**PLANNING DIRECTOR'S SPECIAL PERMIT
FOR SINGLE FAMILY RESIDENTIAL IN A PUD**

FILE: P99-095

PROJECT NAME: Kimball Hill Homes in Natomas Crossing - Parcel 21

Exhibit 1
P99-095

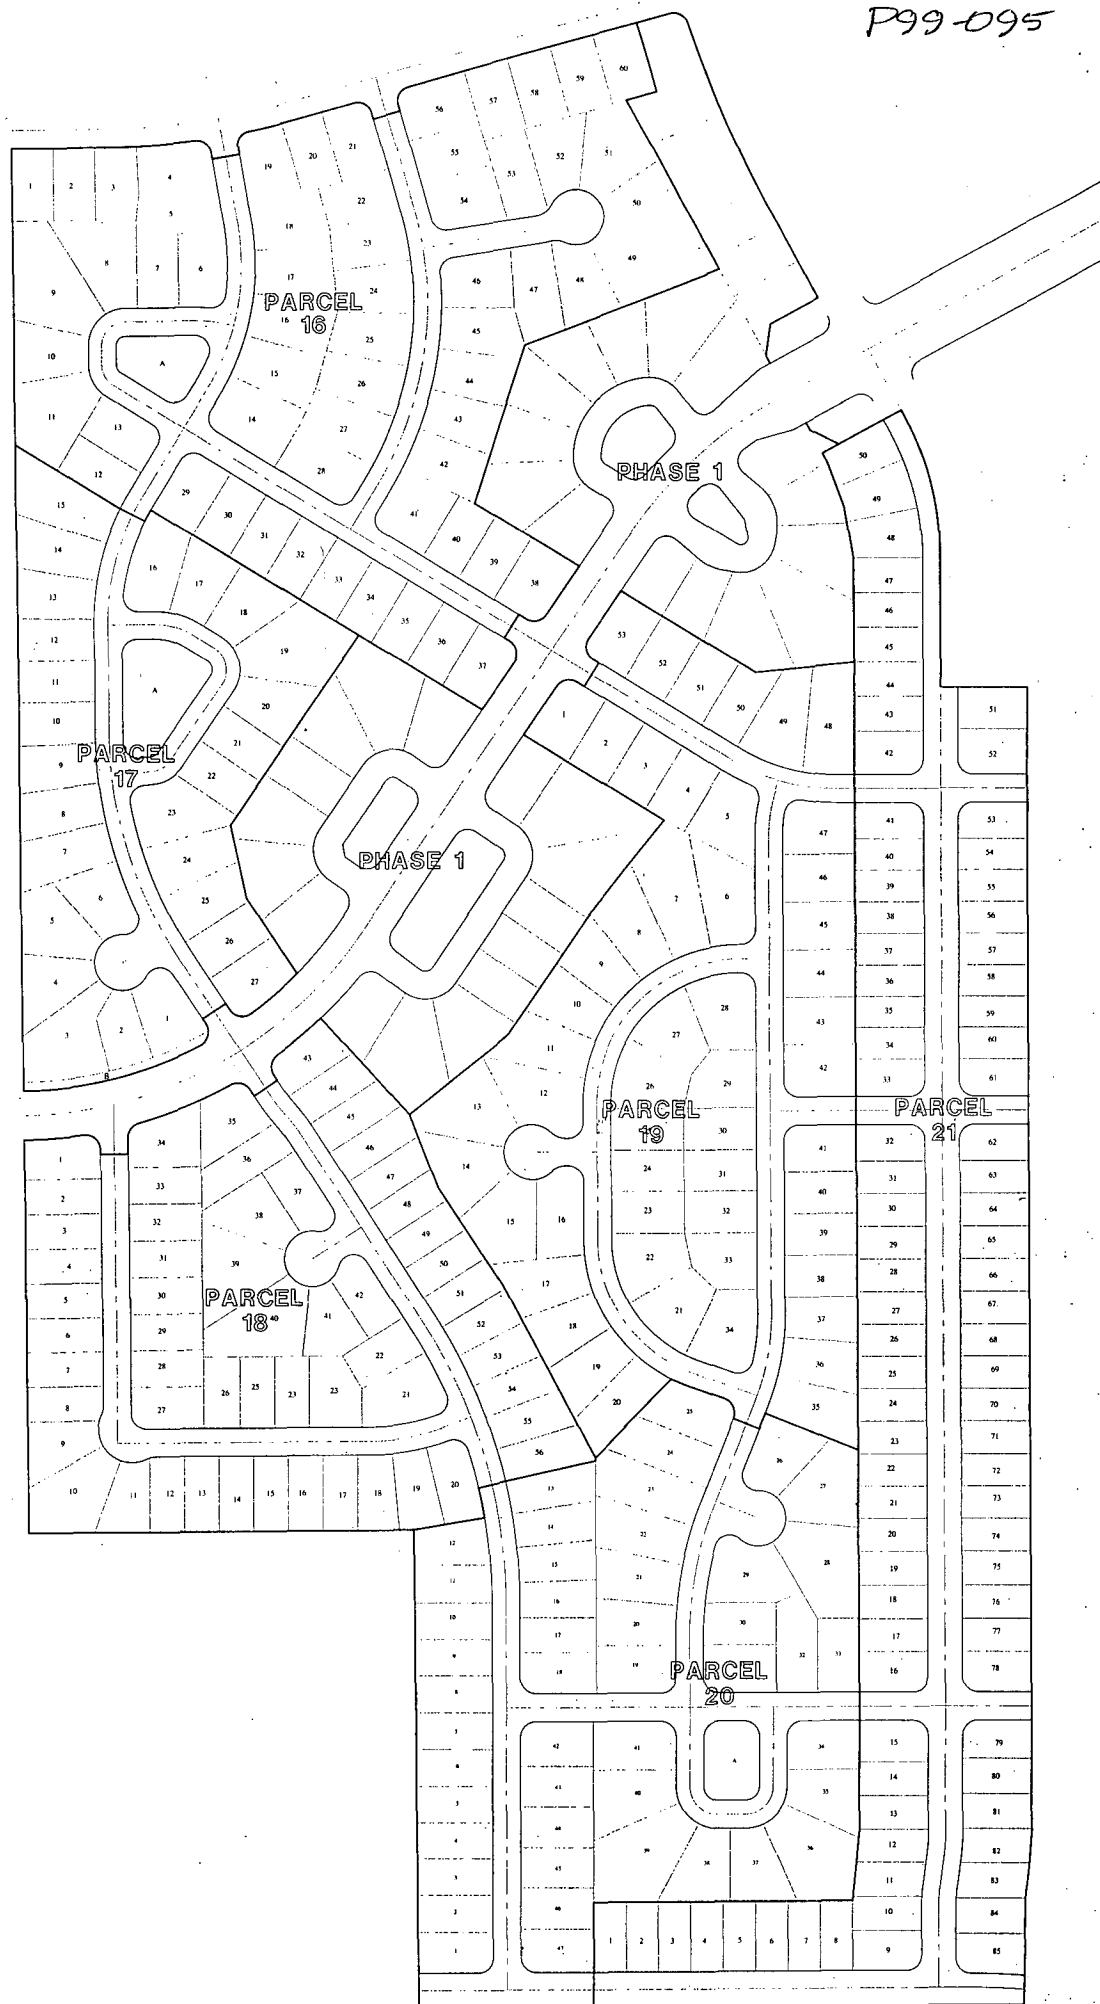
Corner Lots: Twelve corner lots are included in the village (see Exhibit 1). All three plans are acceptable on corner lots - the Versailles plan is encouraged on corner lots (see below). On each corner lot, the driveway shall be located away from the intersection of streets.

Fences and Walls: All lots within the subdivision front on to Innovator Drive or the east-west street along the southern boundary of the project area. No masonry walls are needed within the village. The Natomas Crossing PUD Guidelines do not specify the type of fencing to be used within the neighborhood. At a minimum, wood fencing with wood posts is to be provided. A maximum six foot tall fence may be used behind the front and street side setbacks and a maximum of 3'-6" fence may be used in the front yard. The backyard fence shall commence at the back of the house on corner lots leaving the side yard landscaping exposed to the side street.

Exhibit 2
P99-095

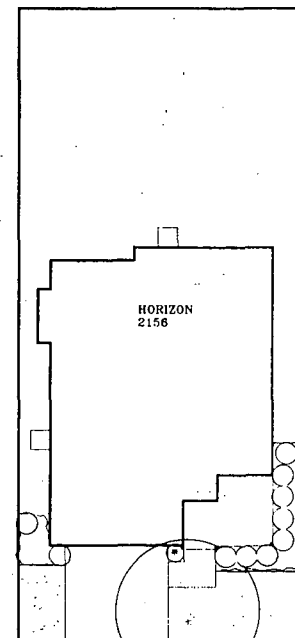
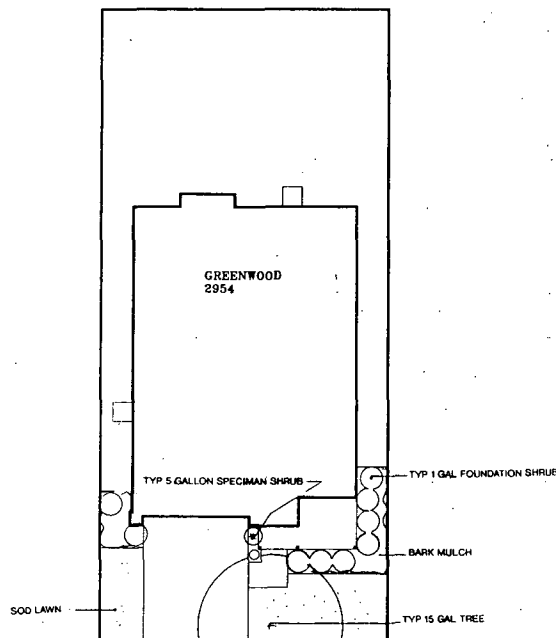
Landscaping: Typical lot landscaping plans are provided for both the interior lots and the corner lots (see Exhibit 3). Fifteen gallon size street trees will be provided on an average spacing of 25 feet on center. The street tree designated by the Natomas Crossing PUD Guidelines (Table 4) for Innovator Drive (Road J) is *Gleditsia tricanthos*. Also, each corner lot will be planted with three street trees on the street side at 25 to 30 feet on center. Front yard and street side yard landscaping materials,

including accent trees, foundation and specimen shrubs, ground cover with minimum spacing of 12 inch on center with decorative bark, and turf, shall be provided, in addition to the street trees, as shown on Exhibit 3. Plant materials shall be primarily selected from the plant list in the North Natomas Development Guidelines, page 22 through 27.

8. Landscaping - Front yard and street side yard landscaping materials, including accent trees, specimen and foundation shrubs, ground cover planted 12 inch on center with decorative bark, and turf, shall be provided, in addition to the street trees. Plant materials shall be primarily selected from the plant list in the North Natomas Development Guidelines page 22 through 27. All planting selections should consider appropriate location, ultimate size, pruning needs, and water usage to reduce greenwaste production and improve efficient water use. All planting shall conform to City standards for sight line requirements at intersections and

VERSAILLES

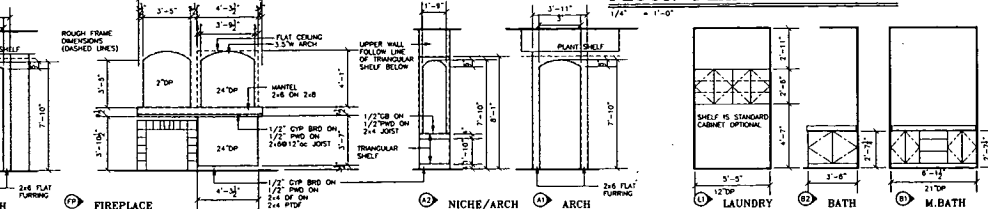
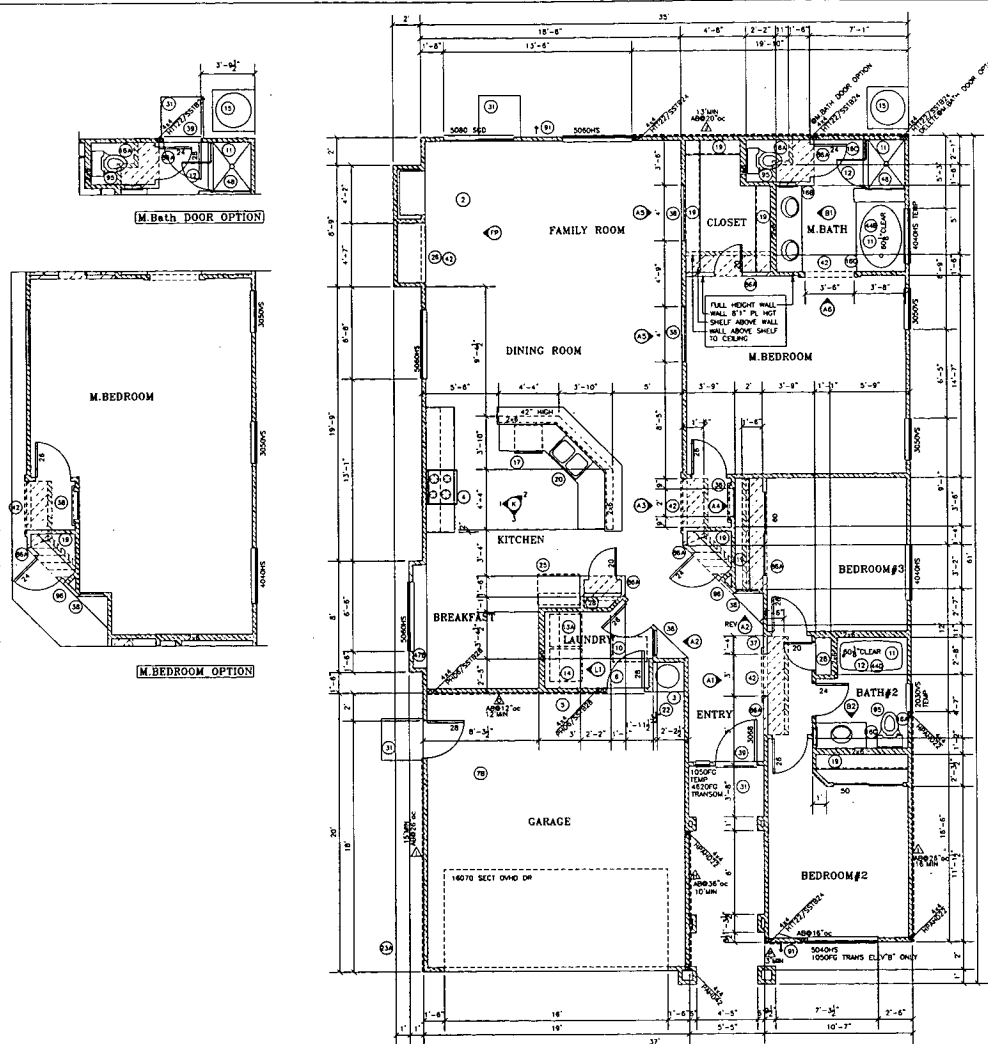
Versailles: Only single story home; 2 car garage faces the street; garage projects 2 feet in front of bedroom 2 with an optional den; bedroom 2 / den and entry face the street; Option: bedroom 2, which faces the street, can be converted to a den.

Versailles: Planning staff is concerned about the Versailles plan because: 1) no living area faces the street unless bedroom 2 is converted into a den, and 2) the main entry is located 13 feet behind the garage and front of the house. Planning staff would suggest at least one of the following conditions be required for the Versailles plan: 1) the plan shall be located on a corner lot; 2) the plan shall include the den option; or 3) the plan shall have a courtyard incorporated to encourage the use of the front yard. The applicant has agreed to these conditions.

1. The design of the proposed house plans shall substantially conform to the plans as shown on Exhibits 1 thru 6, specifically:
 - a. Elevation B - Country shall have wood siding and brick standard as shown on the attached exhibits and Elevation C- Early California shall have stucco and brick standard as shown on the attached exhibits;
 - b. Each Versailles plan shall be constructed with at least one of the following requirements: 1) the house shall be constructed on a corner lot; 2) the plan shall include bedroom 2 converted to a den; and/or 3) the plan shall include a courtyard feature to encourage the use of the front yard;
 - c. Roof pitch shall be no less than a 5 to 12 pitch;
